REMARKS

Appl. No. 10/085,129
Amdt. Dated June 15, 2004
Reply to Office Action of Jan. 15, 2004
Annotated Sheet Showing Changes

Fig.1

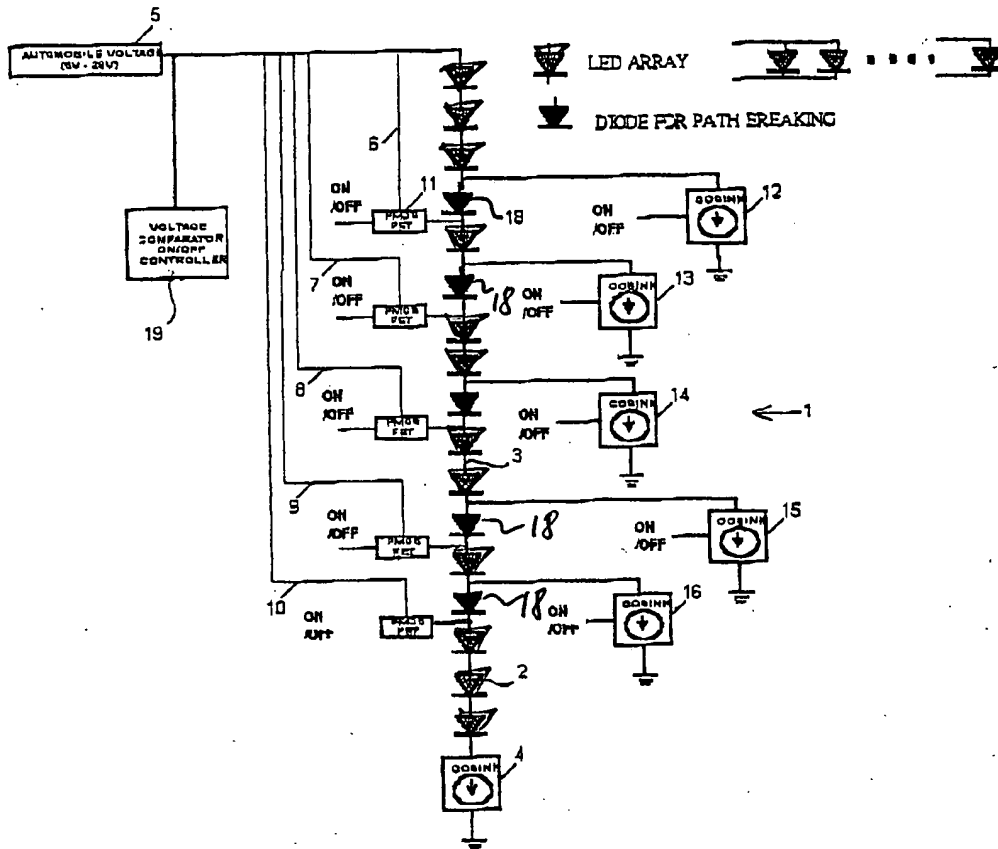
Figs. 1 – 2 of the application have been objected as containing certain clerical errors. Figs. 3 – 5 of the application have been objected as failing to comply with 37 CFR 1.84(p)(5) because they do not include proper reference signs.

Applicant respectfully submits that the amended Figs. 1 – 6 have corrected the clerical errors and provided reference numerals. More specifically, in Fig. 1, the lead lines for numeral 18 have been provided. In Figs. 1 – 6, the symbols for Array LEDs and Path Breaking Diodes are clearly distinguished. In Fig. 2, the caption has been corrected to indicate the proper range is “6.0V – 10.1V.” In Fig. 3, the missing reference numeral 11 has been added. In Fig. 4, the missing reference numerals 8 and 19 have been added. In Fig. 5, the missing reference numeral 19 has been added. In addition, in Figs. 1 – 6, a connection line has been added between the PMOFET of path 10 and the nearby line between LED Array 18 and Path Breaking Diode 2 to complete a circuit with the constant current device 4 (See page 9, line 13). No new matter has been added by the above amendments.
